# RIDGE PORT NORTH 3RD ADDITION

RE: S/D 99-62 -- Final Plat of RIDGE PORT NORTH THIRD ADDITION

RE: S/D 99-62 -- Final Plat of RIDGE PORT NORTH THIRD ADDITION

**CASE NUMBER:** S/D 99-62 -- RIDGE PORT NORTH 3<sup>RD</sup> ADDITION

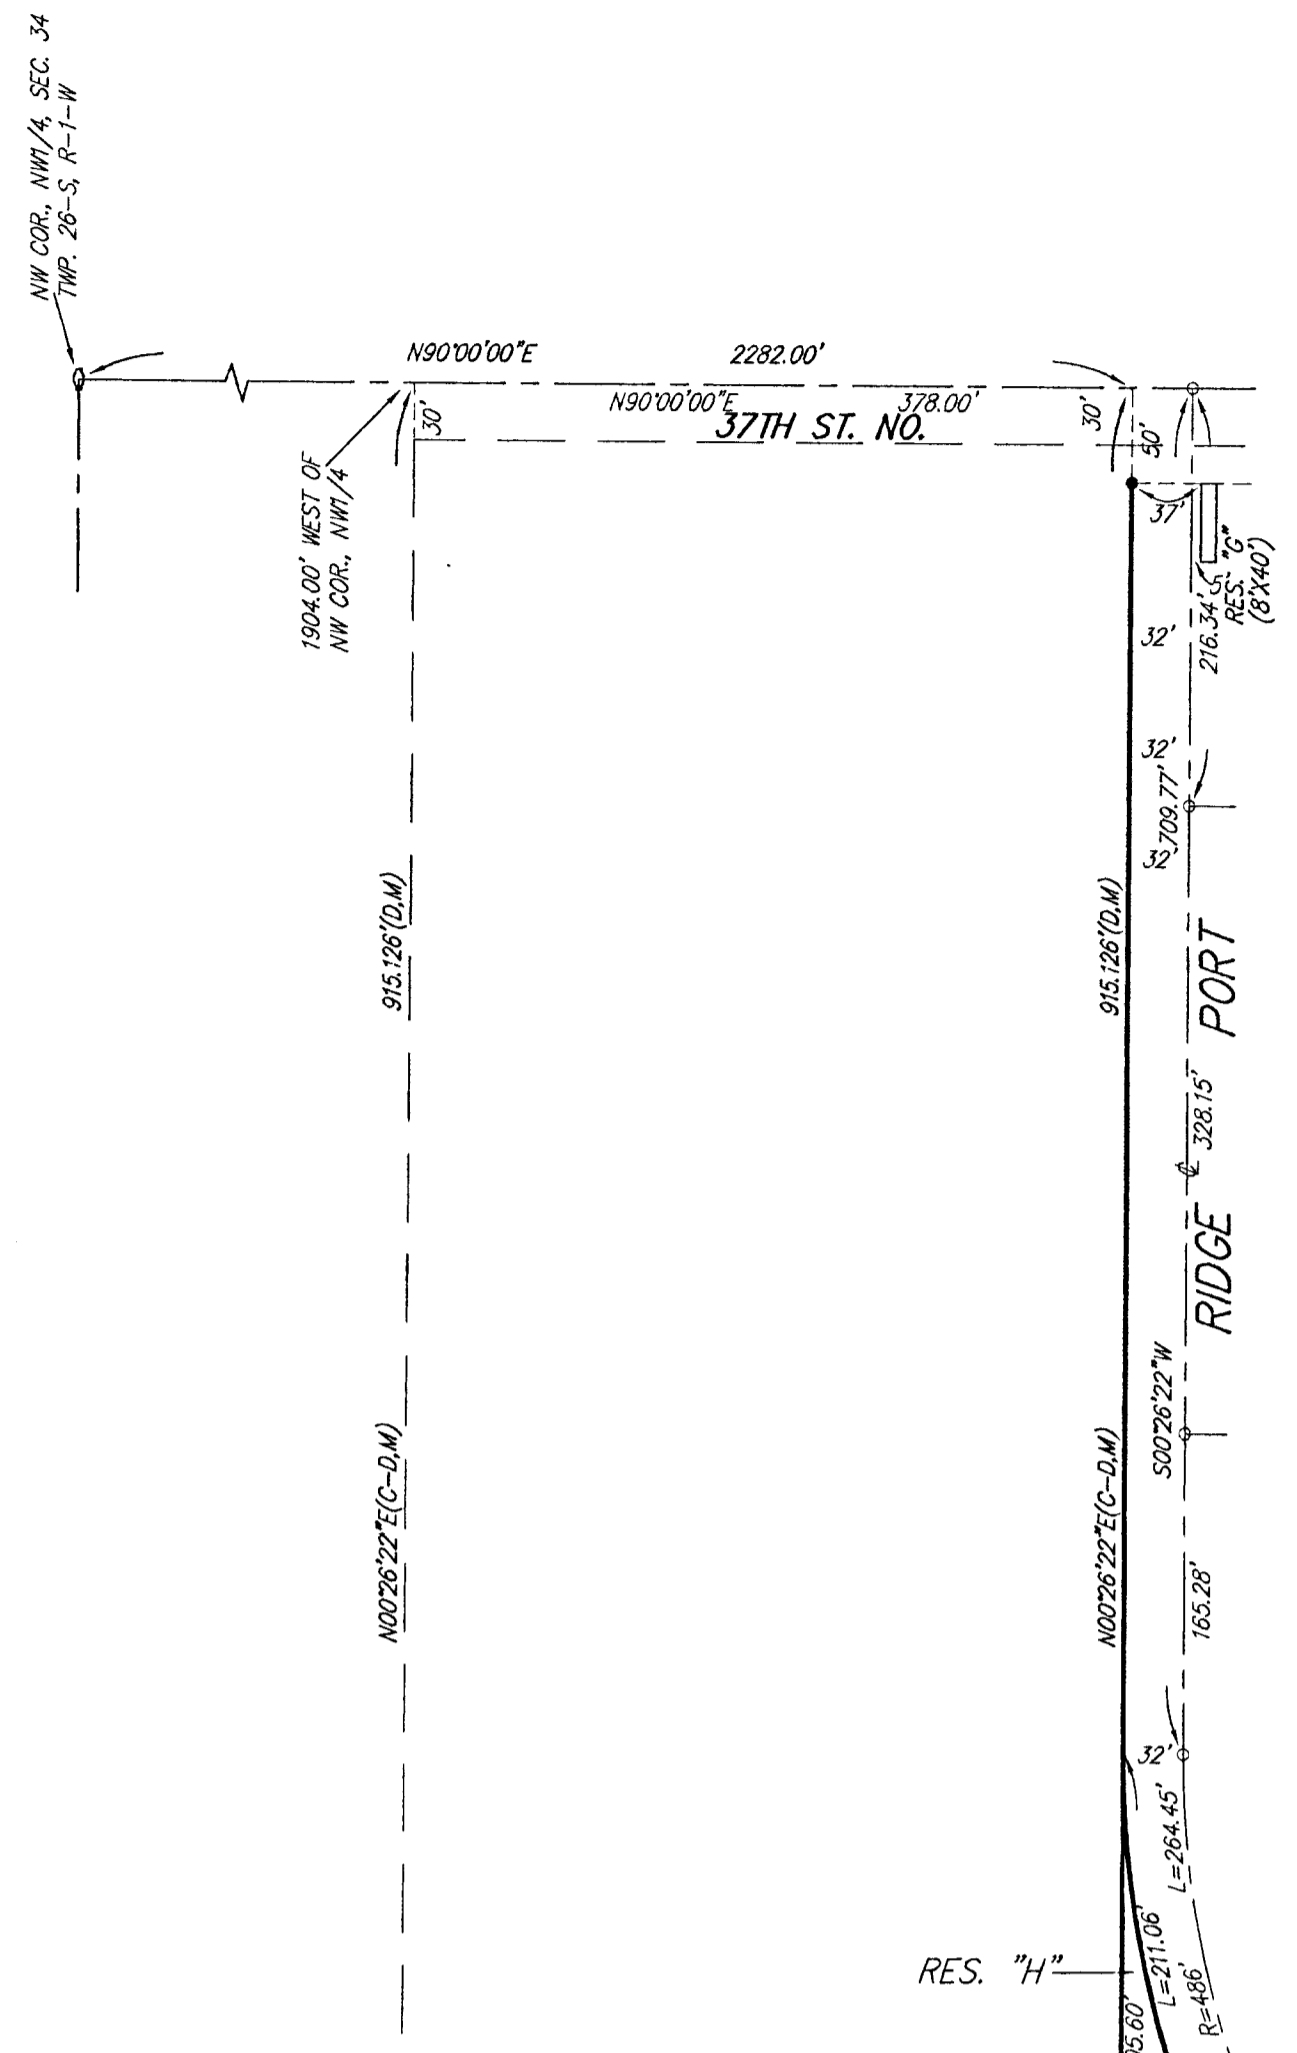
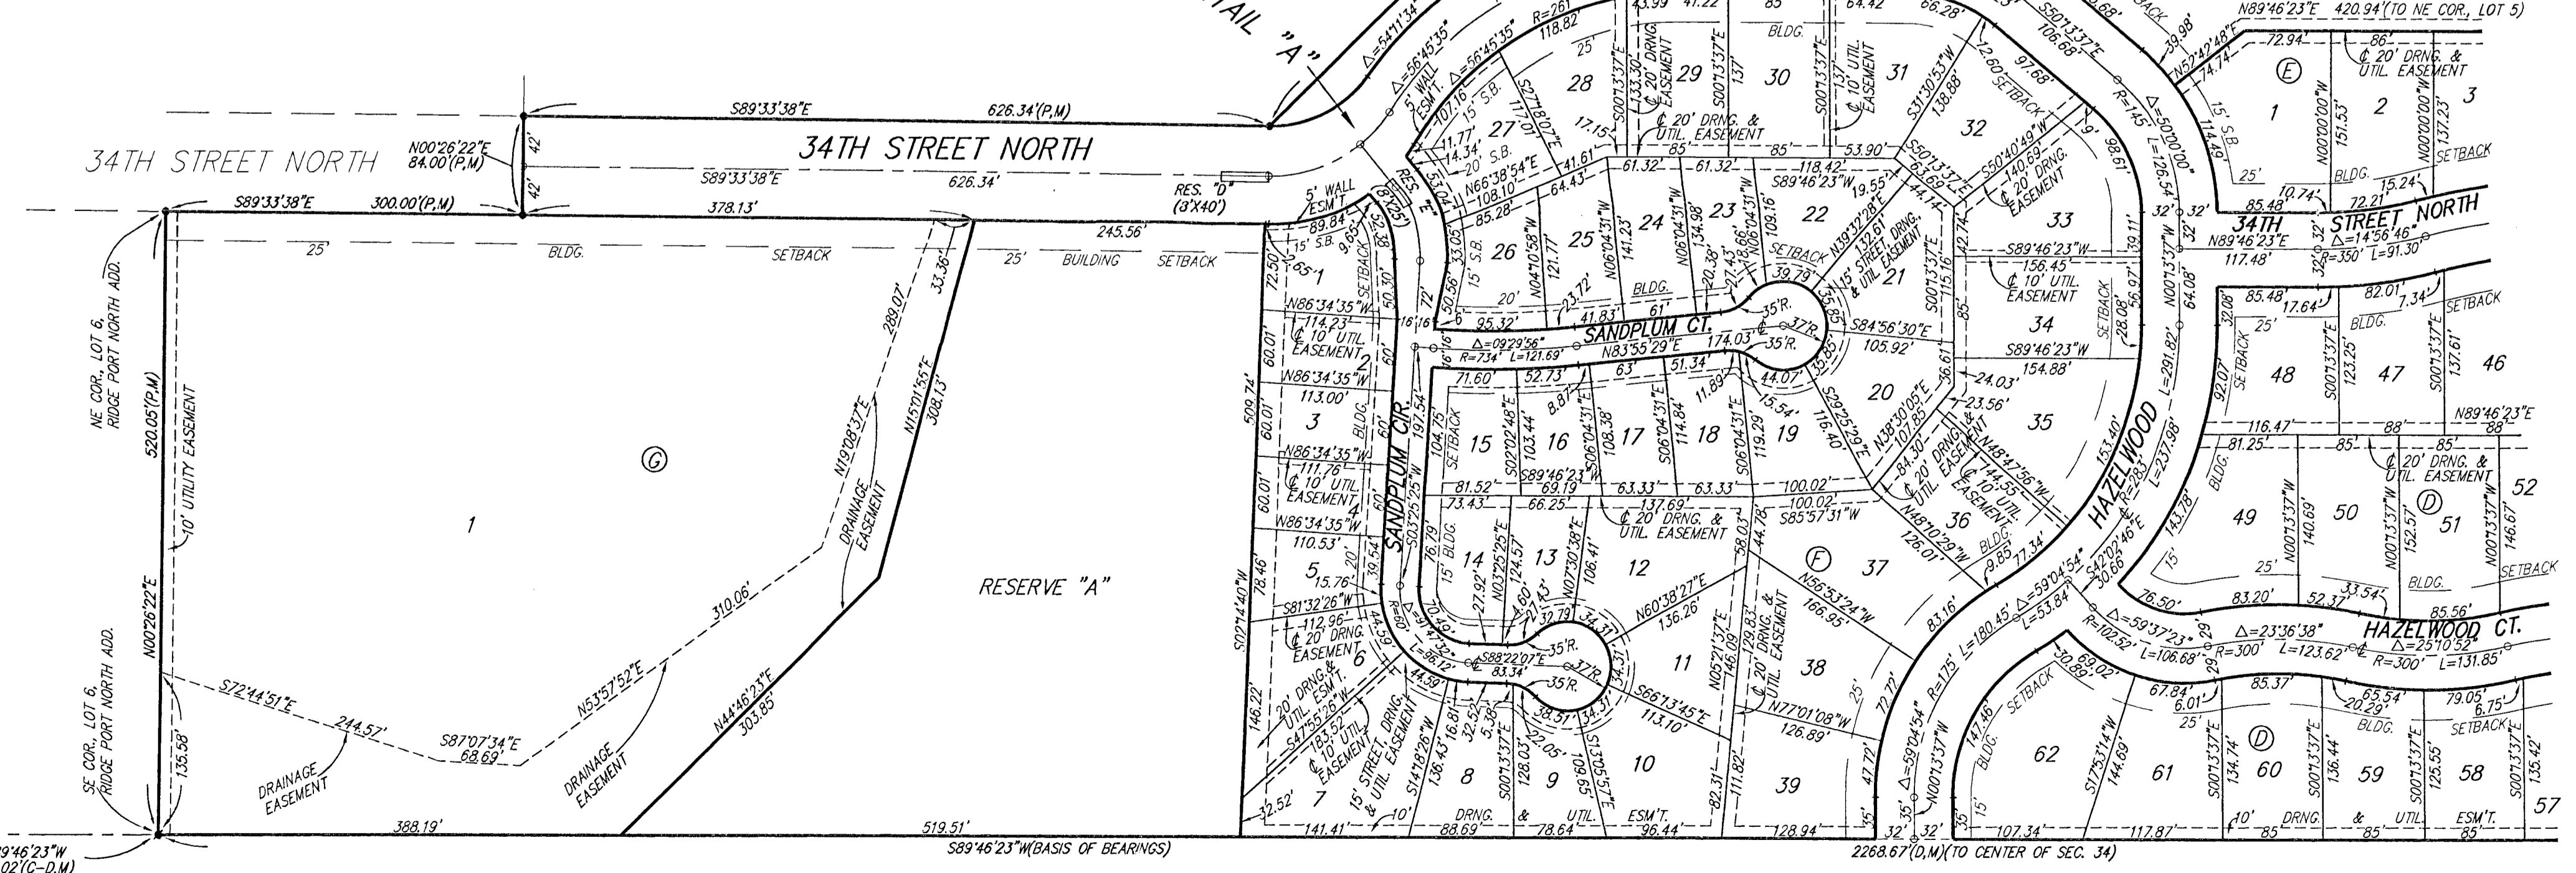
City Fire Department needs to comment on the plat's street names. *The final plat tracing needs to indicate the following street name changes: 34<sup>th</sup> St. North Circle to 34<sup>th</sup> Circle North, and 34<sup>th</sup> St. North Court to 34<sup>th</sup> Court North.*

- P. The dimensions on the north and south lines of Lot 27, Block 1, do not match the dimension on the north line of Lot 28, Block 1.

- Q. The triangular piece of land north of Lot 1, Block 2, needs to be labeled as a Reserve.
- R. This property is within a zone identified by the City Engineers' office as likely to have groundwater at some or all times within 10 feet of the ground surface elevation. Building with specially engineered foundations or with the lowest floor opening above groundwater is recommended, and owners seeking building permits on this property will be similarly advised. More detailed information on recorded groundwater elevations in the vicinity of this property is available in the City Engineers' office.

- P. The dimensions on the north and south lines of Lot 27, Block 1, do not match the dimension on the north line of Lot 28, Block 1.
- Q. The triangular piece of land north of Lot 1, Block 2, needs to be labeled as a Reserve.
